**October 8, 2024
7:00 PM
Planning Board Agenda**

Continue public hearing and continue review of applications for Site Plan Approval and Subdivision Approval, 19 Henry Street, townhomes, submitted by Lori Joseph Builders, Inc.

Re: Application for Site Plan and Subdivision Approval for Proposed Townhomes
Supplemental Submission
Premises: 19 Henry Street, Beacon, New York – Transitional (“T”) District
Tax Parcel ID: (5954-36-955796)

TO: John Gunn, Chair, and the City of Beacon Planning Board
FR: KARC Planning Consultants, Inc.
DATE: October 4, 2024
RE: 19 Henry Street Site Plan, Lori Joseph Builders, Inc.

DRAINAGE EASEMENT #1
SCALE: 1"=20'

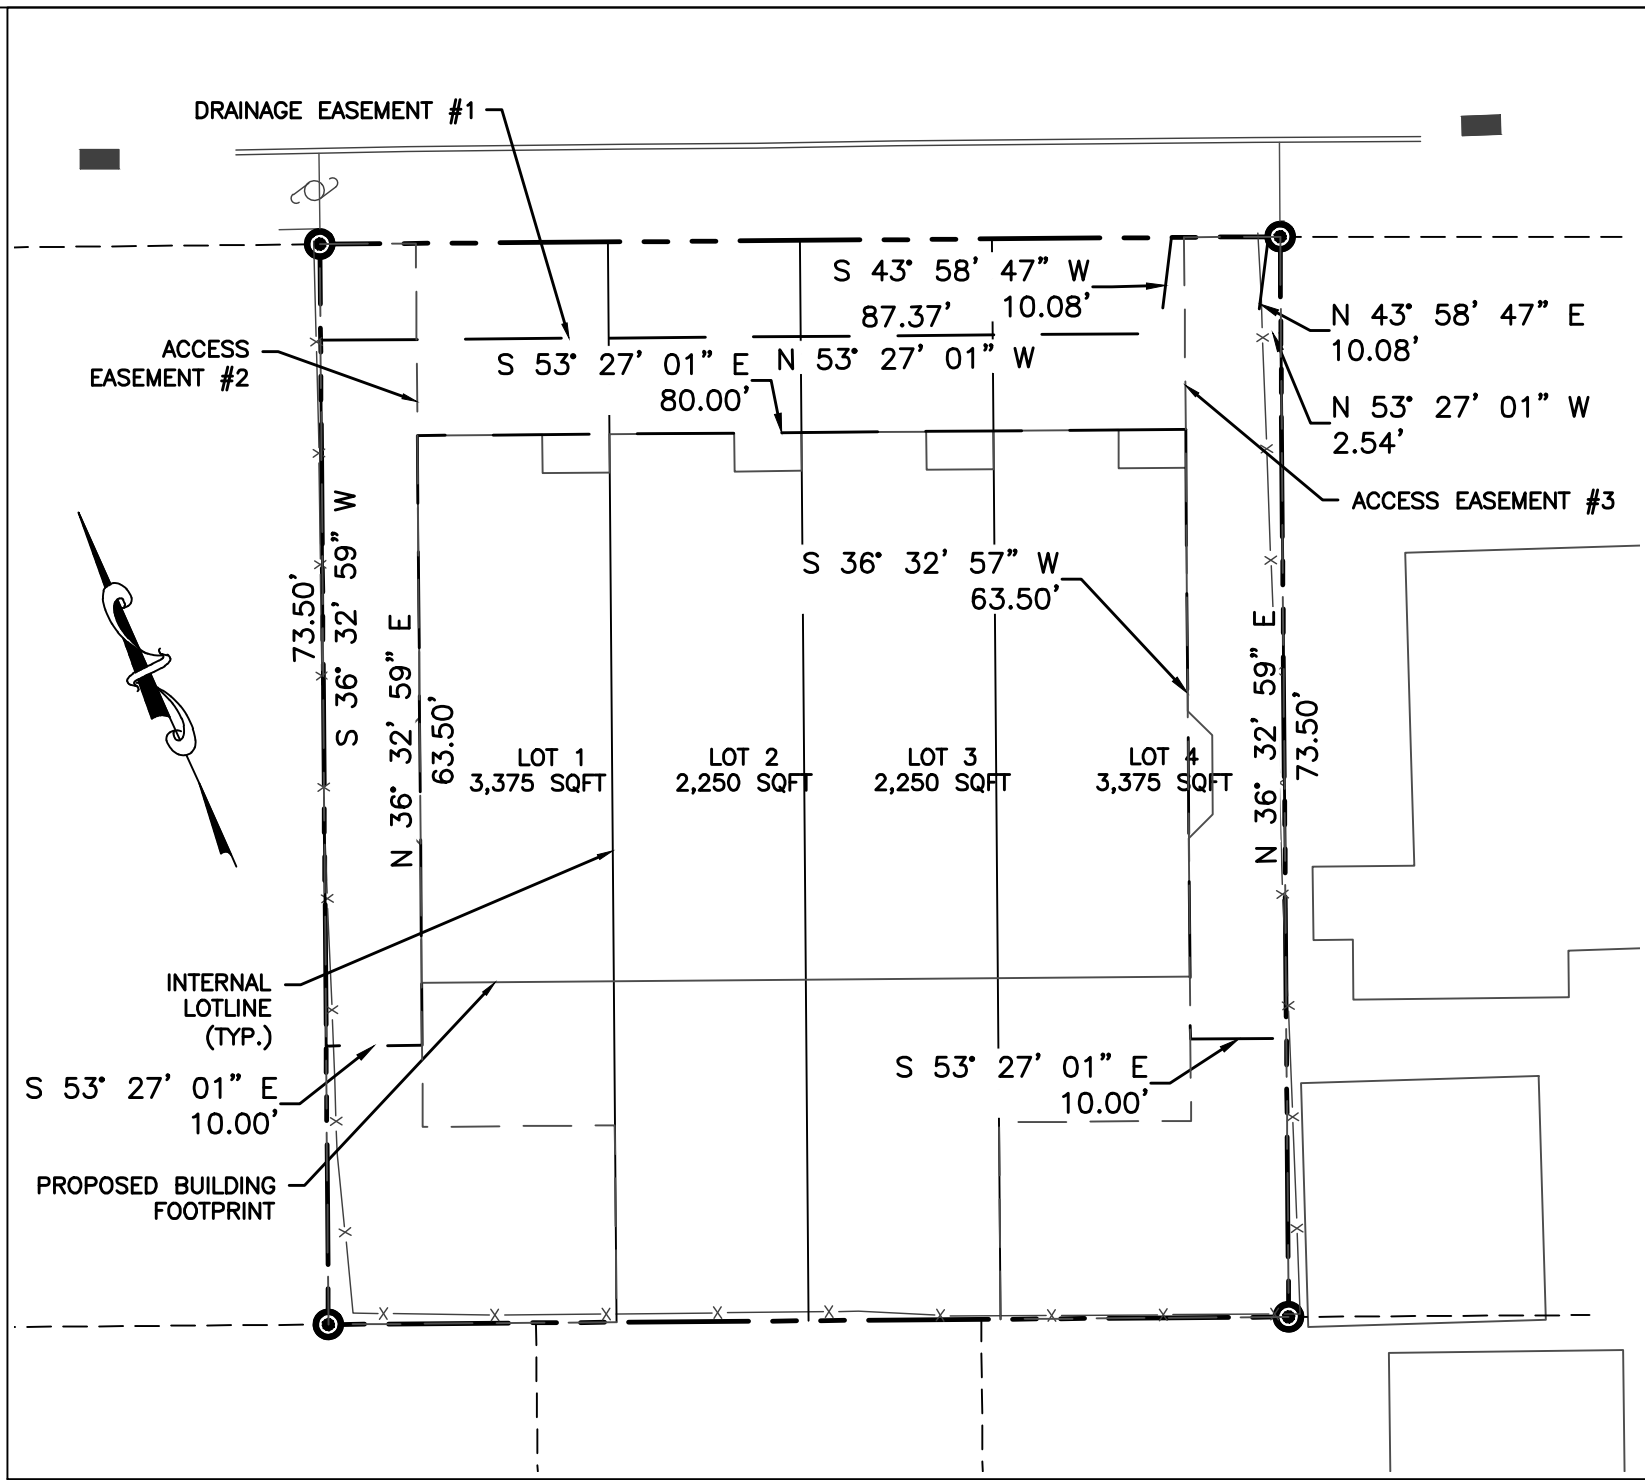
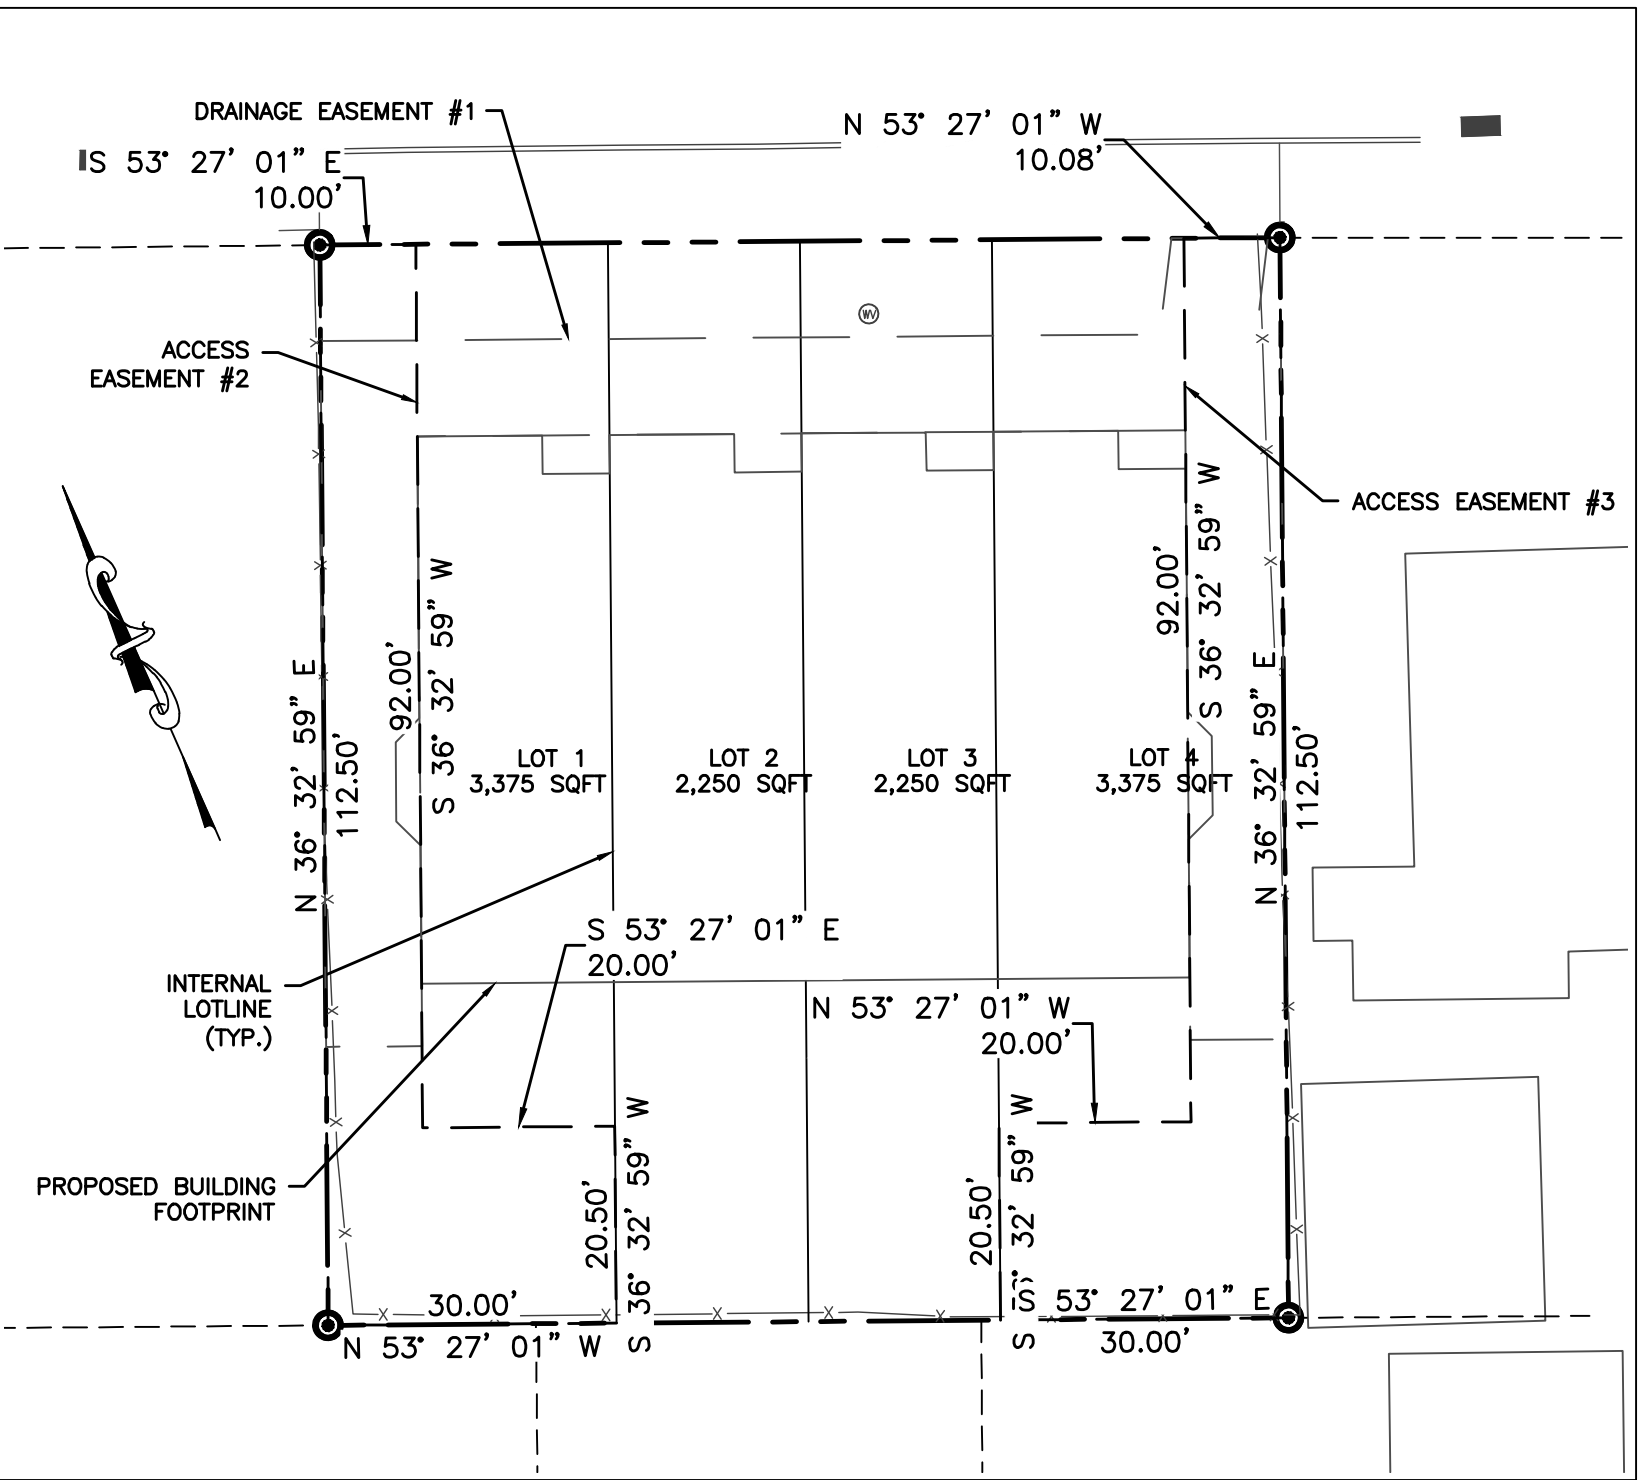
1. Have provisions been made that if a homeowner installs fence along their lot line to the rear of the property that the neighbor will still have access?
2. The "Drainage Easement #1" layout on the plan should have the access easements removed for clarity.
3. The "Access Easements #2 & #3" layout on the plan should have the drainage easement removed for clarity.

LANDSCAPE & LIGHTING PLAN
SCALE: 1" = 10'

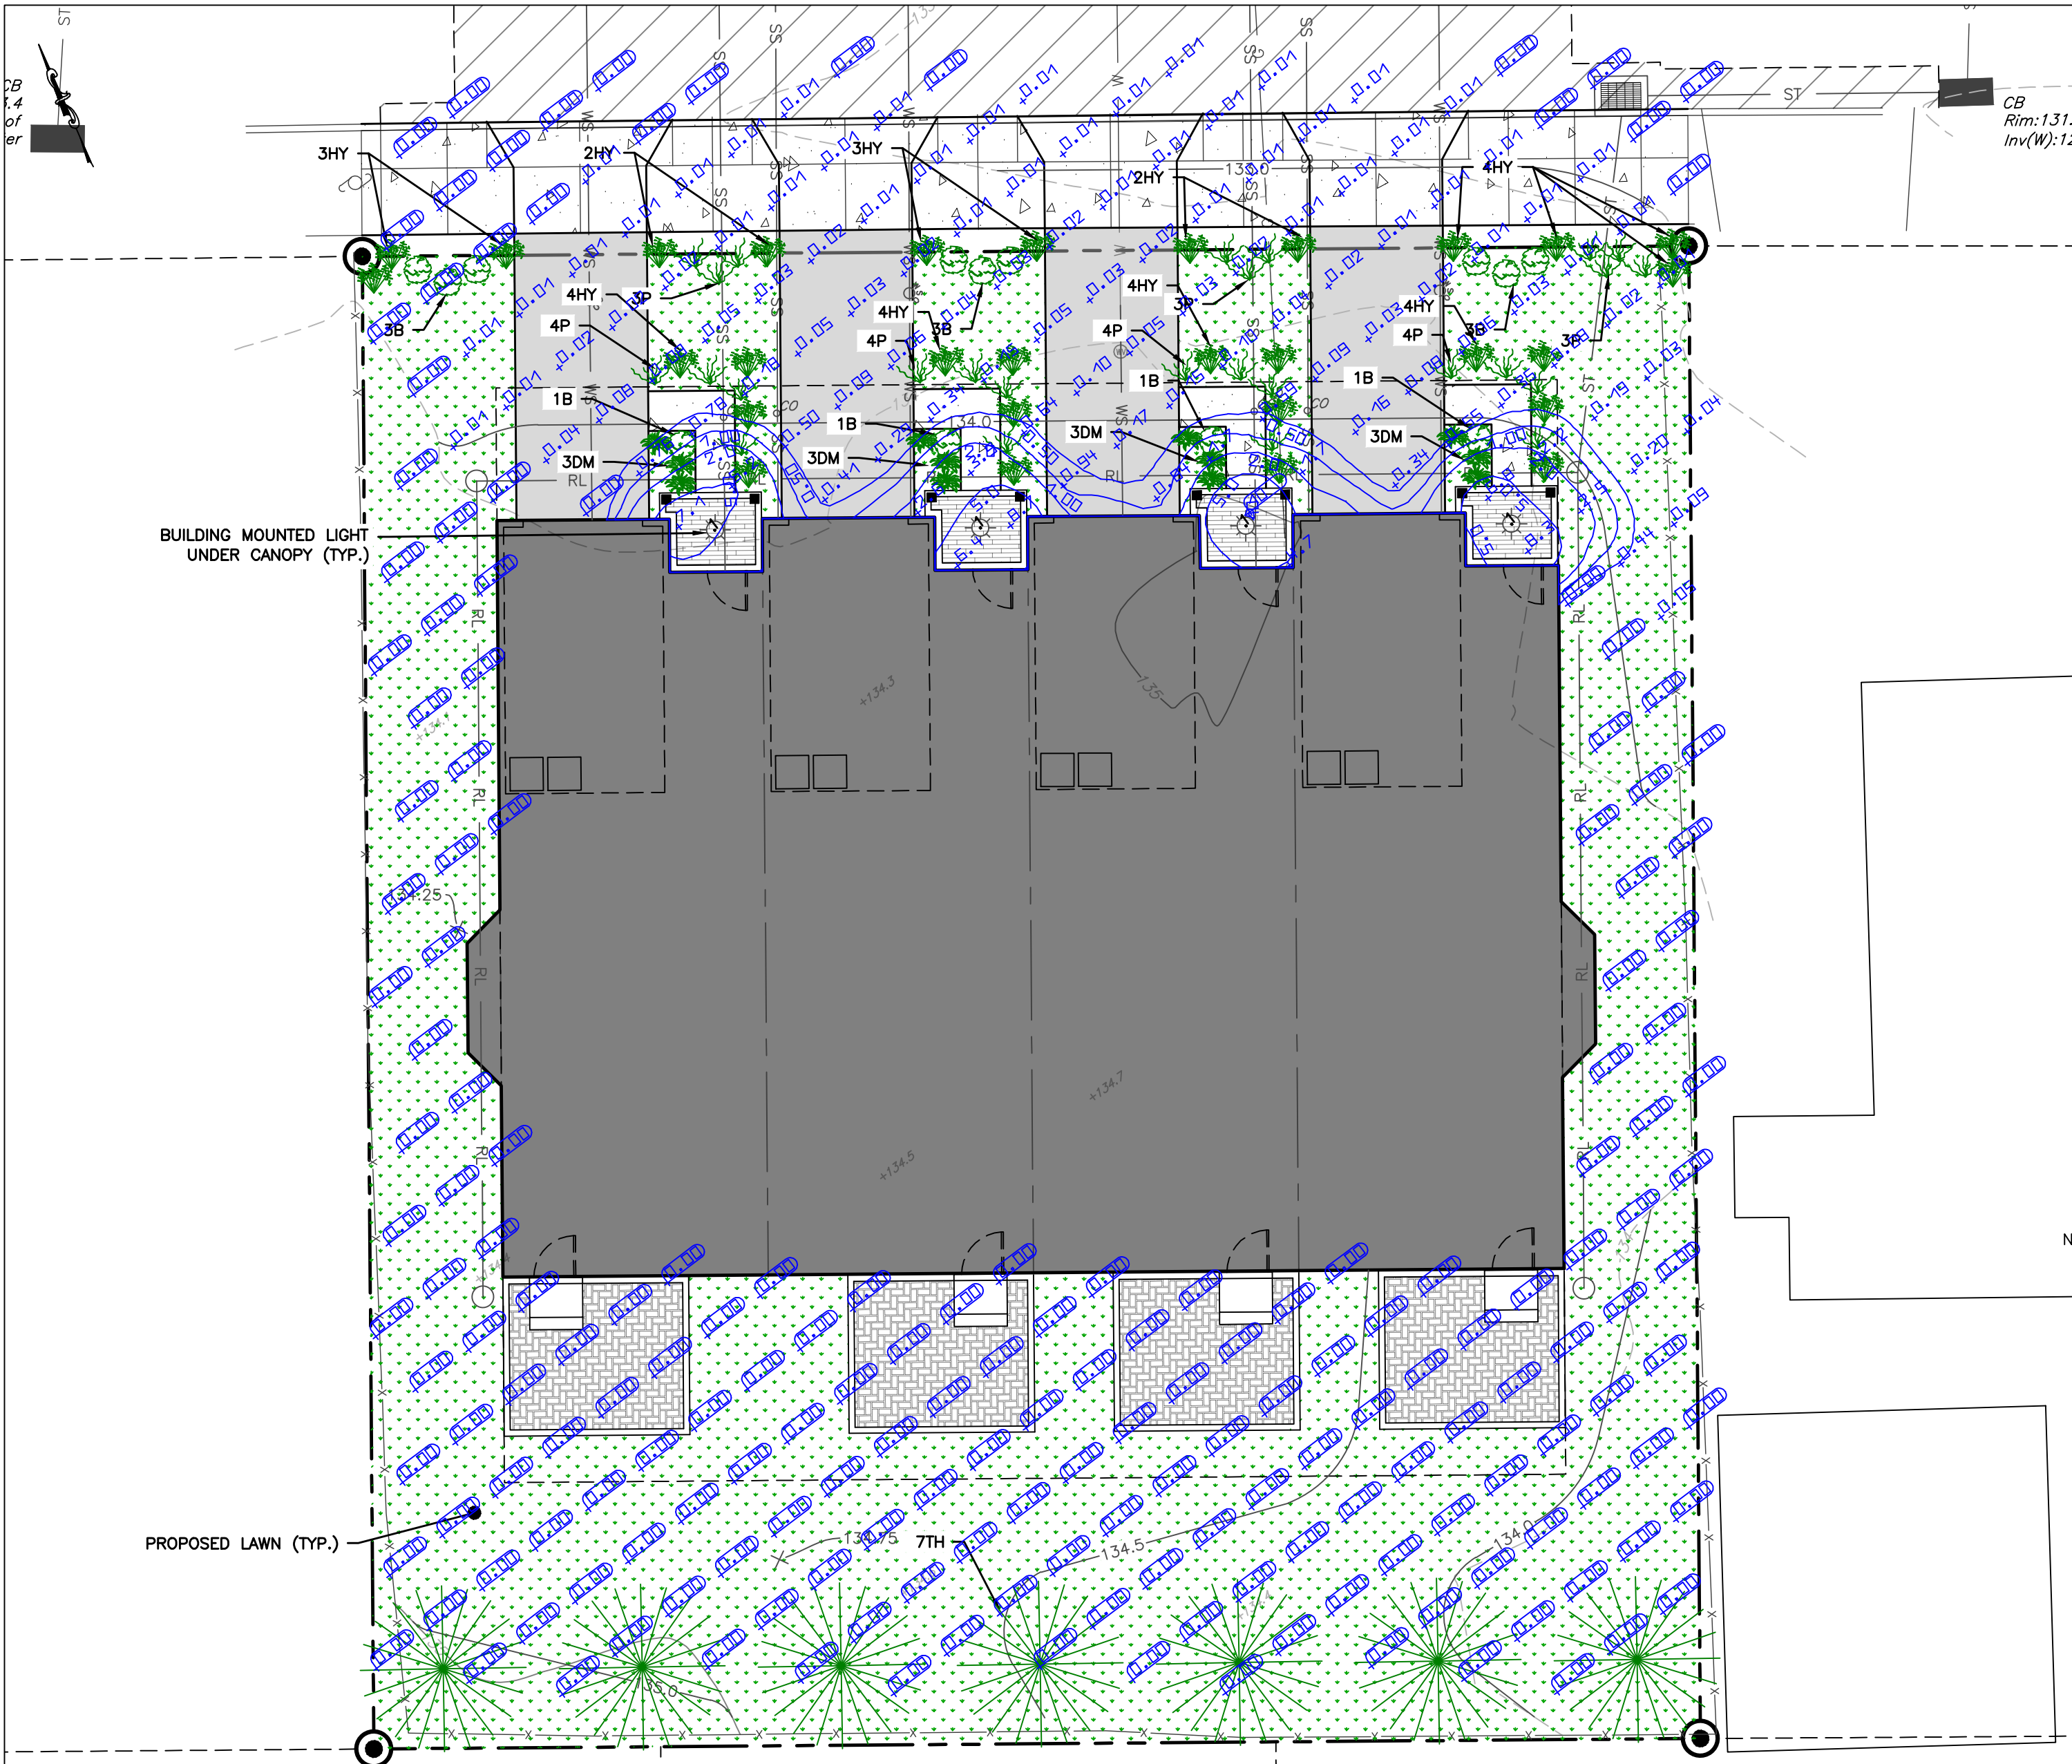
- *Site Plan Sheet 5:*
 - The planting plan has been updated to include seven (7) Thuja Green Giant Arborvitae along the rear property line to provide year-round screening of the rear yards from adjacent properties, where Red Maples were previously proposed.
- *Updated Subdivision Plat:*
 - The Subdivision Plat was revised to include references to the proposed drainage easement over the proposed lots for the underground roof drainpipe system and to include the pedestrian access easements over proposed Lots 1 & 4 for the benefit of Lots 2 & 3, respectively, for access to their rear yards outside the building.

1. The "Tree Planting" detail on Sheet 5 of 6 notes to refer to Sheet 2 plans for locations. This note should be removed, as the planting locations are shown on this sheet.
2. As giant thujas are being provided for screening to the adjacent parcels to the rear, a note(s) should be added to the plan that the homeowner is responsible to maintain the trees on their respective parcel, and to replace it if the tree dies or is taken down.

1. **Lighting Plan:** The Calculation Summary table on sheet 5 of 6 states that the max lighting level proposed is 10.3 fc. This appears to be a typo as this level of lighting is not indicated in the photometric plan and the stated average lighting level is 0.27 fc. The max lighting level in the table should be corrected on the final site plan set.

Site Plan Application
Sheet A-106 - Elevations

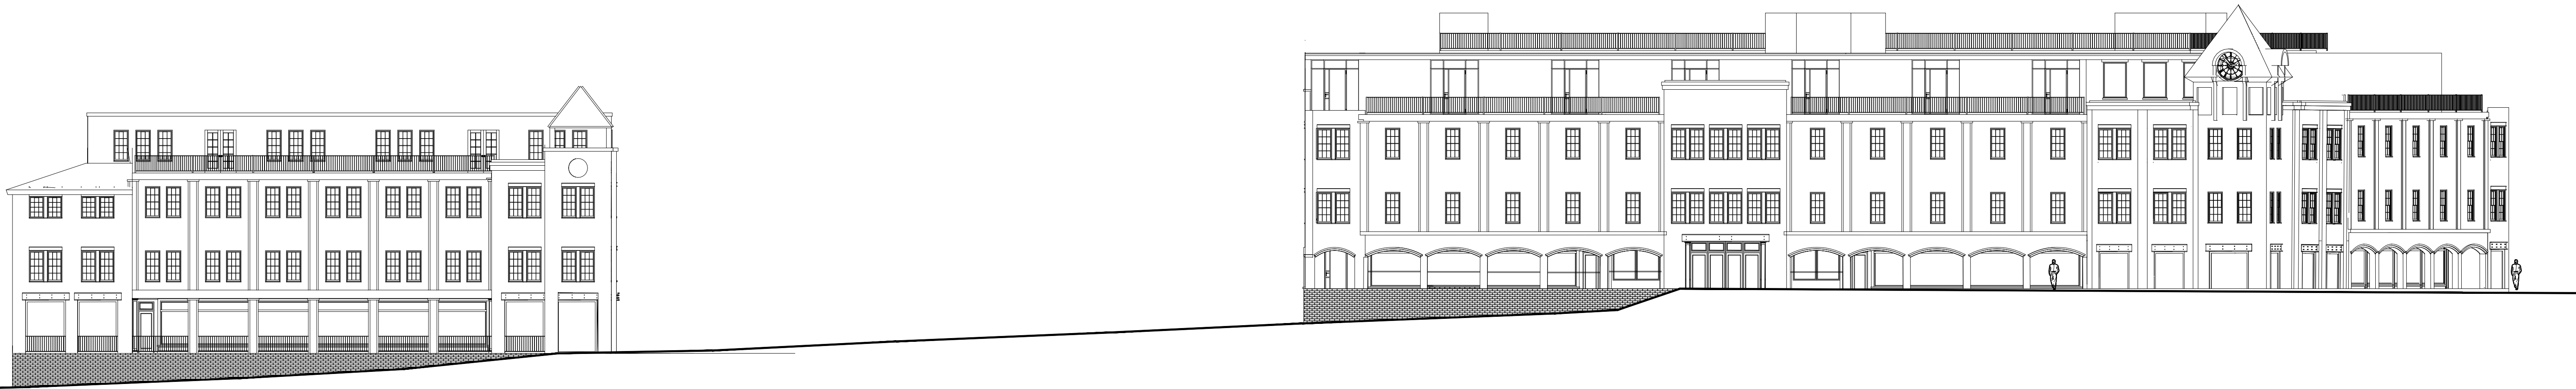
2. It is recommended that the Elevations plan (Sheet A-106) include a view from High Street.
3. The "Views" on the Elevations plan (Sheet A106) should be labeled as where the view is from.
